Addendum No. 1

Project Name:	DDSB Brock HS	Date:	July 16, 2024
Description:	PLP Alterations	From:	Brad Timson, P. Eng.
Address:	C1590 Concession 12 Cannington, ON	Project No:	Z0013706
Client Contact:	Chris Thaler, DDSB	DDSB Tender No:	T24-36

Questions/Responses

DRAFTER:	DESIGNER:	APPROVER:	SCALE: 3" = 1'-0"	DATE: 07-16-2024	DRAWING No: ASK1.1
----------	-----------	-----------	----------------------	---------------------	------------------------------

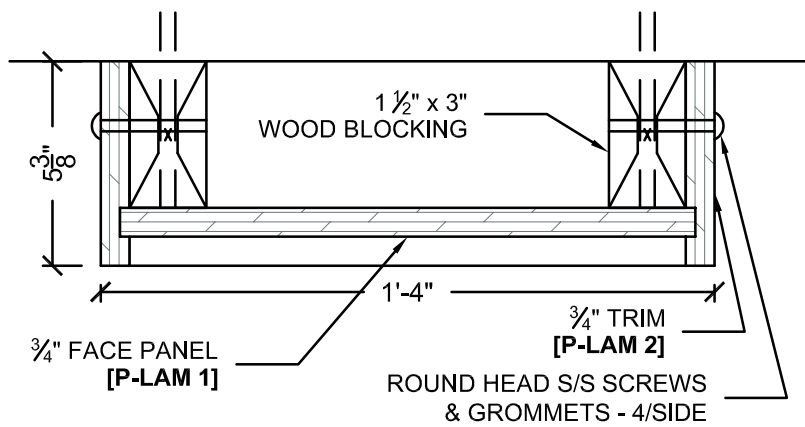
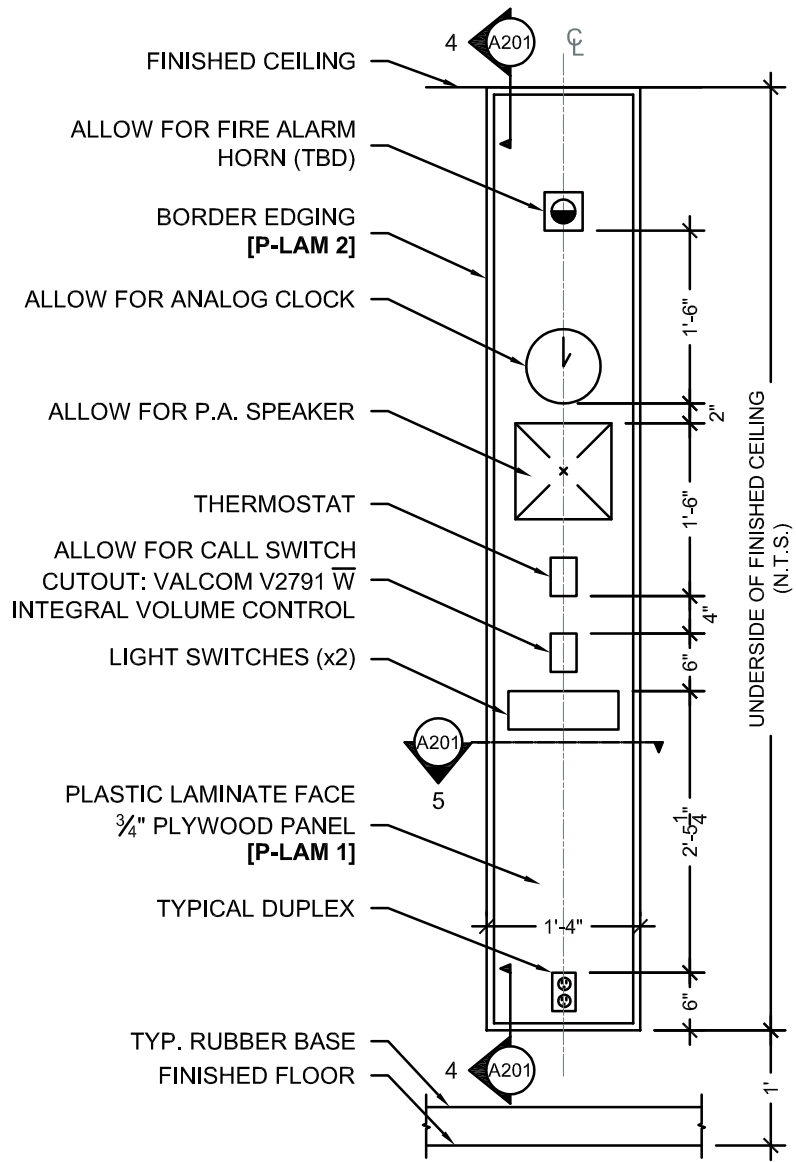
1.6 **Question:** Provide construction detail of control panels.

1.33 Mount new control panels (quantity of two (2)) in Classroom 305 and in Classroom 309. Refer to attached ASK1.1 and ASK1.2 for panel construction.

Response: Refer to attached ASK1.1 and ASK1.2 for control panel details. Provide two new control panels. Confirm exact location for installation on site with Client and Consultant.

2 PROPOSED PLAN
 A104 BROCK HS - SECOND FLOOR - LAUNDRY 307

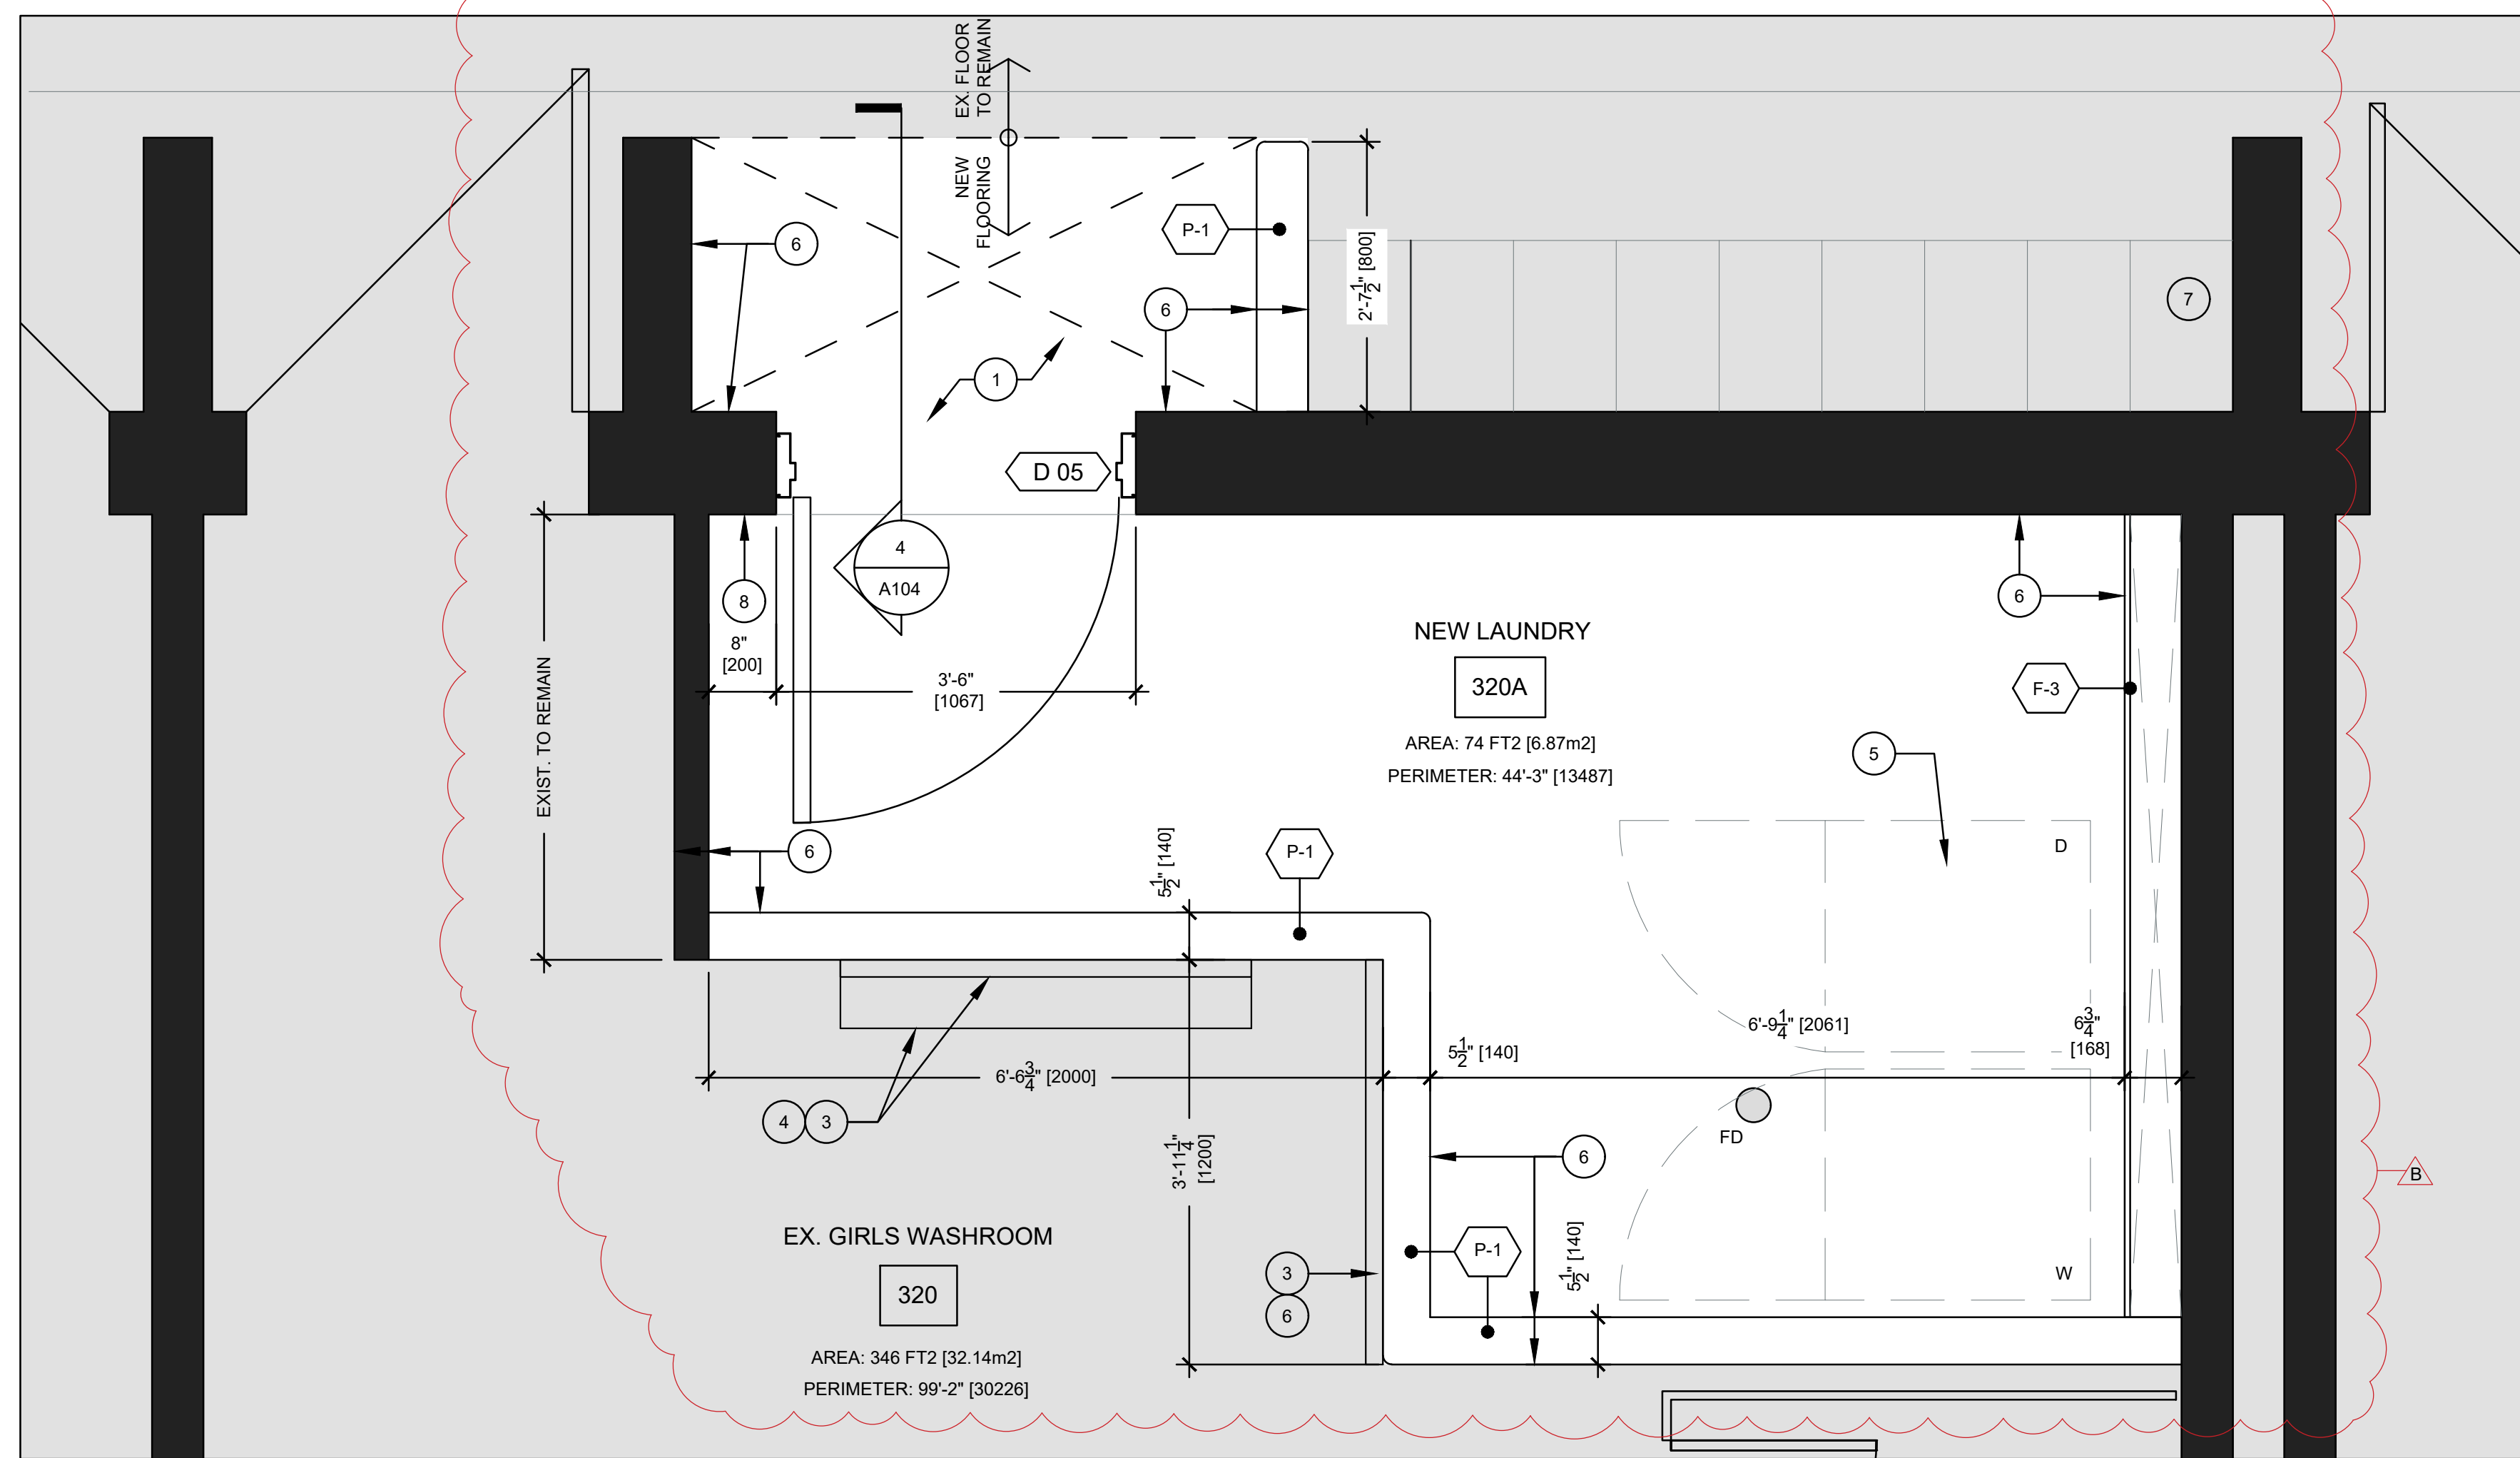
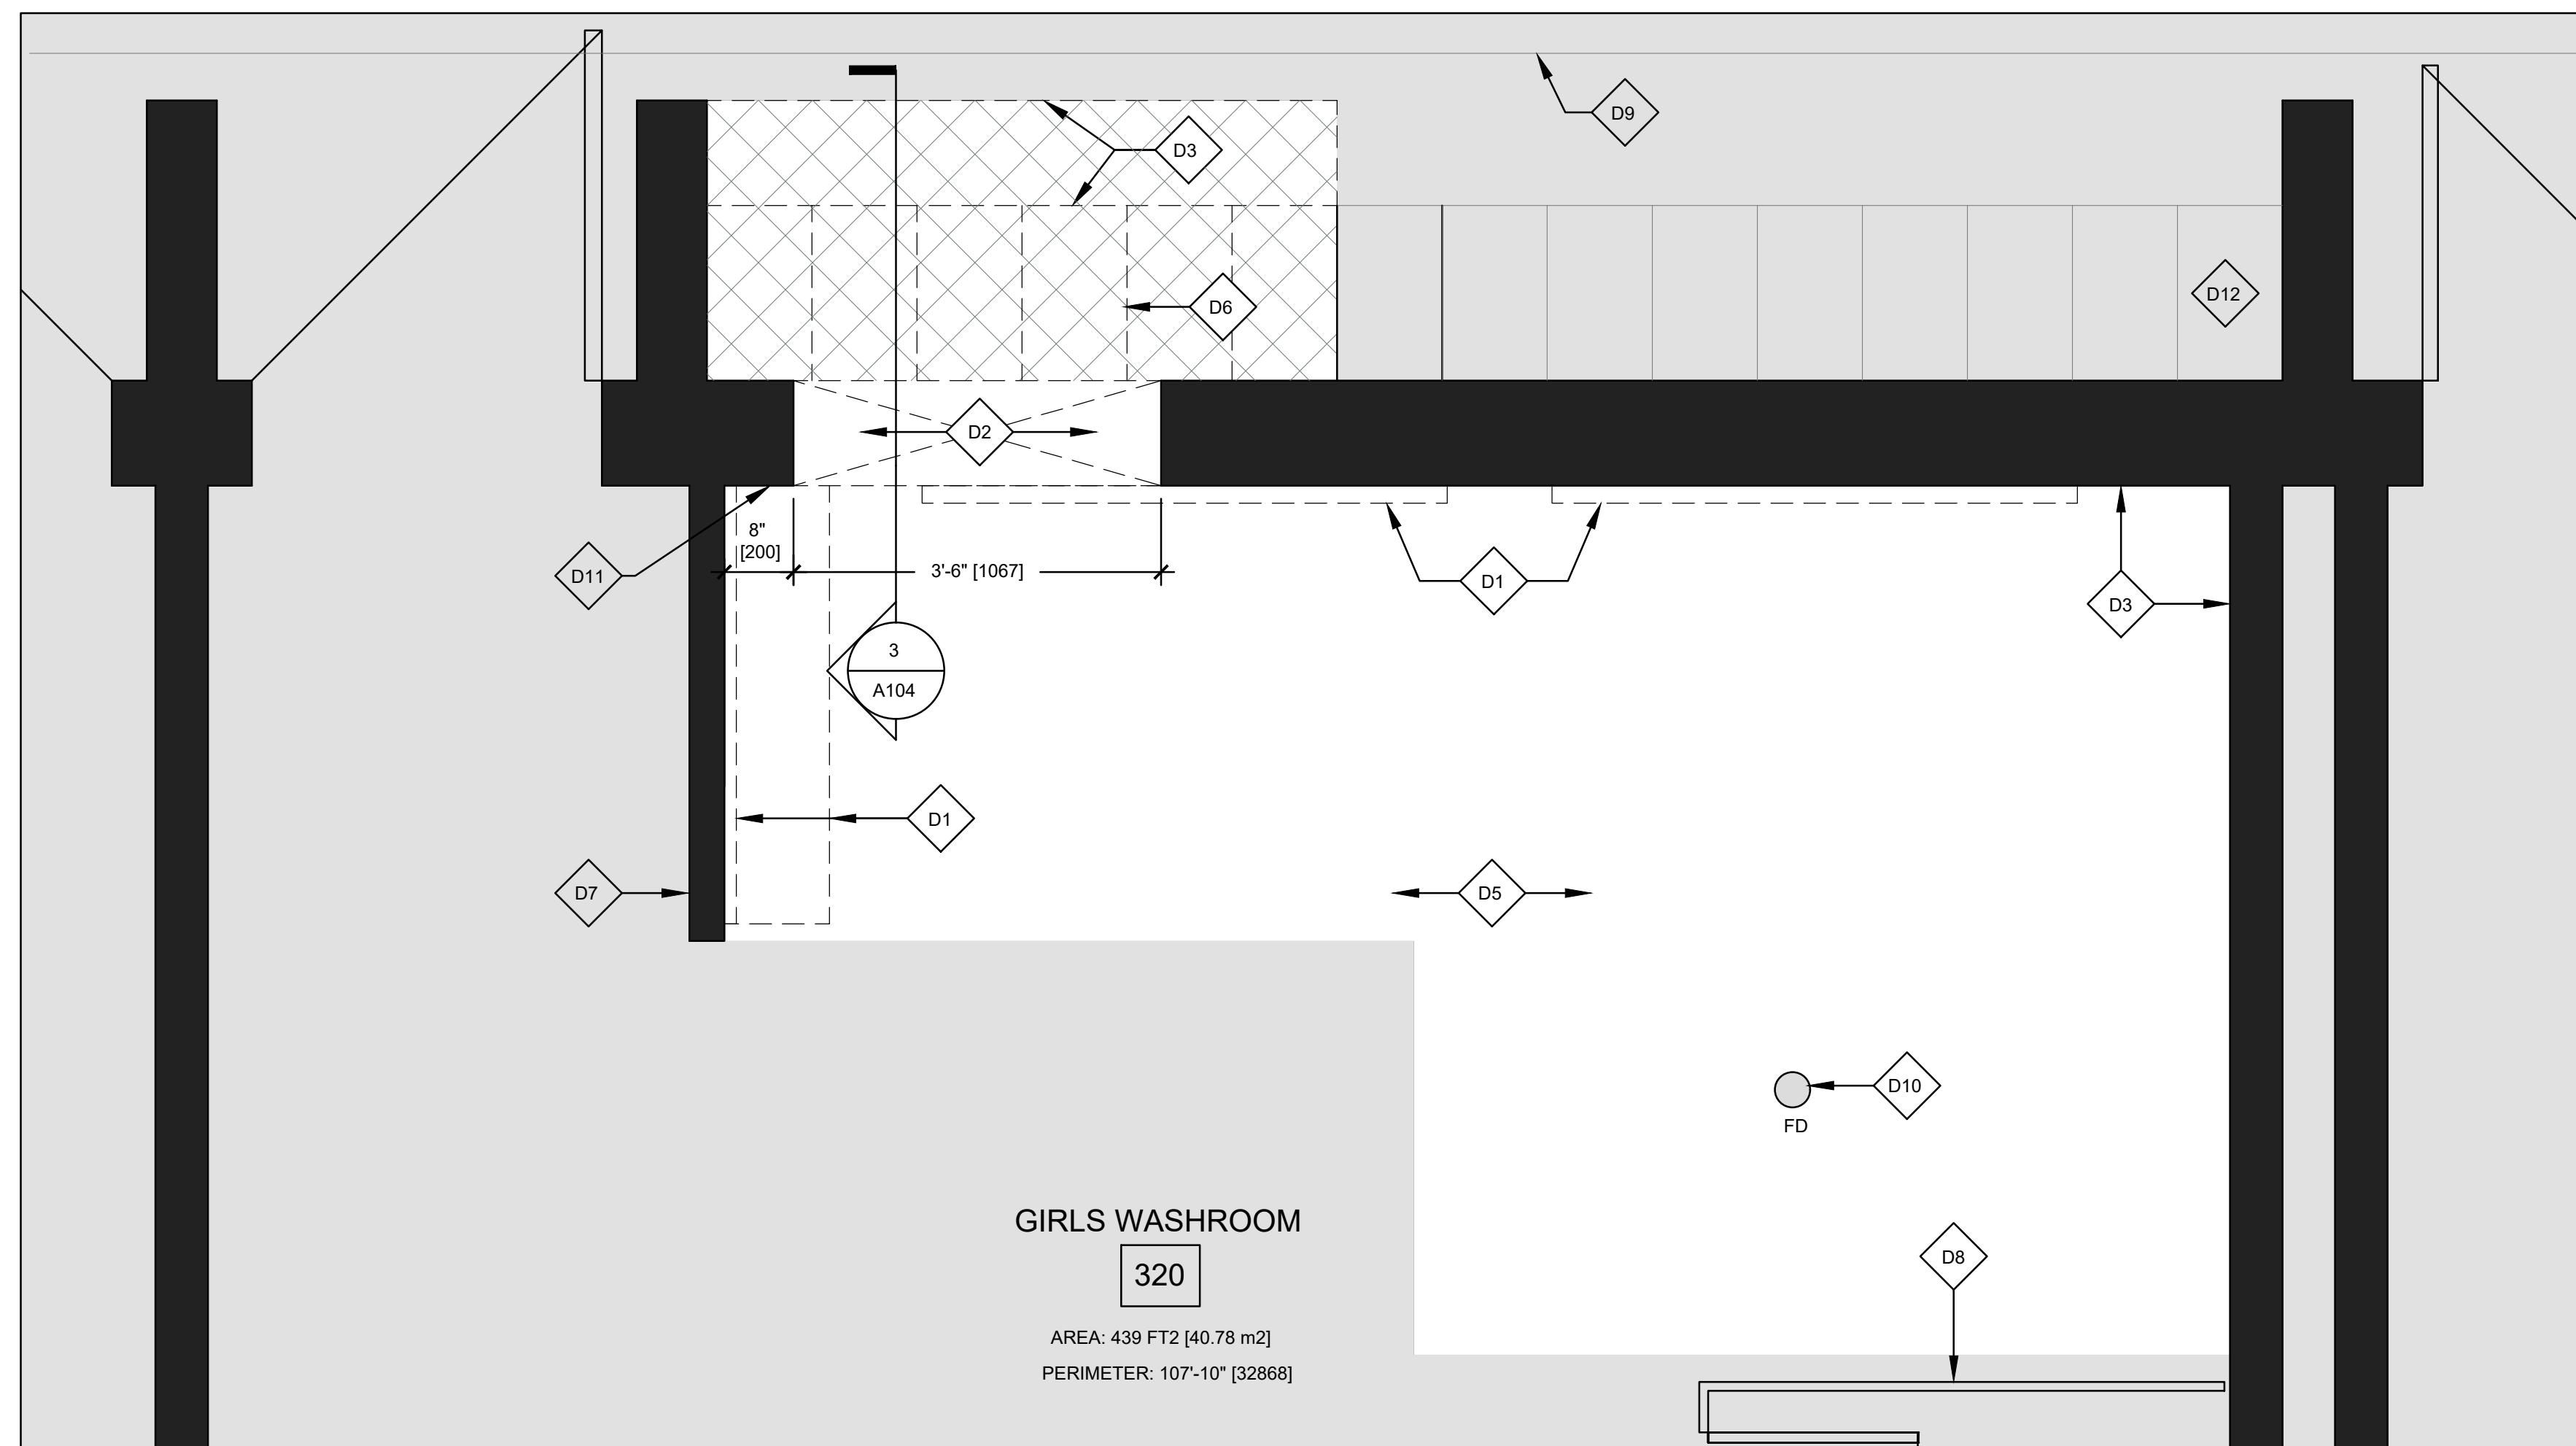
1.15 **Question:** Proposed Note 6 of drawing A104 – Indicate locations where new porcelain tile base is required.

Response: Refer to attached Re-issued Drawing A104 for revised note tags.
